TECHNICAL BULLETIN
K207 UPS7513-2bNAS1
28 JAN 2014

Update Prior to Sale: Rear Suspension Upgrade

XJ Range (X351)

Model Year: 2014
VIN: V51872-V64807

E126985

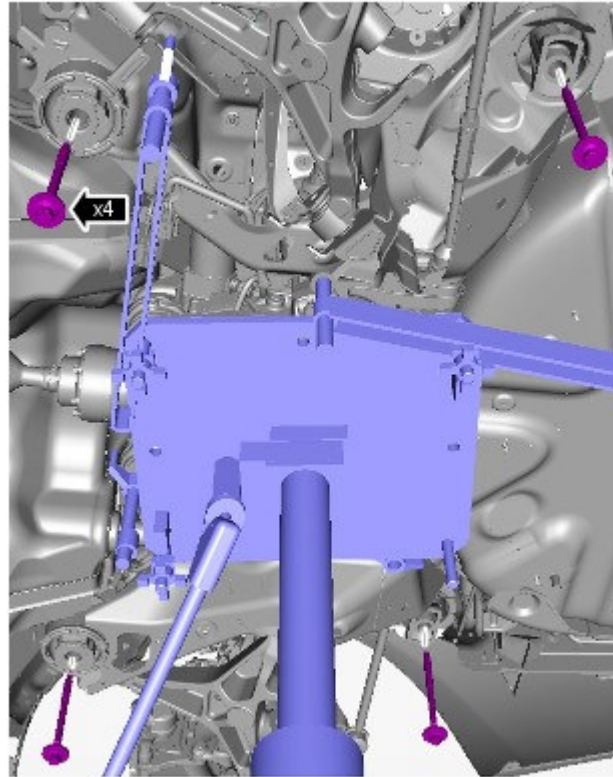
29.  **CAUTION: New rear subframe retaining bolts must be installed; torque to 80Nm + 240°.**

To install the new rear stabilizer bar, reverse steps 3-28.

E162882

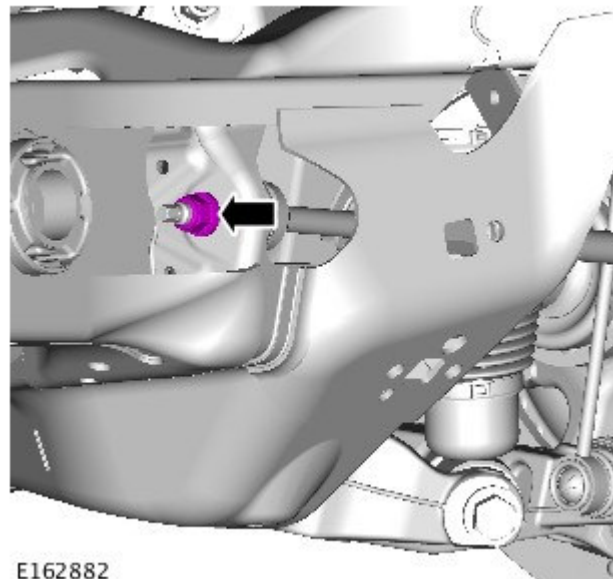
Replace the rear suspension left-side toe link nut:

- Remove and discard the rear suspension left-side toe link nut.
- Install a new rear suspension left-side toe link nut; torque to 90Nm.
 - VINs V51872-V63402: continue to next step.
 - VINs V63564-V64807: lower the vehicle.
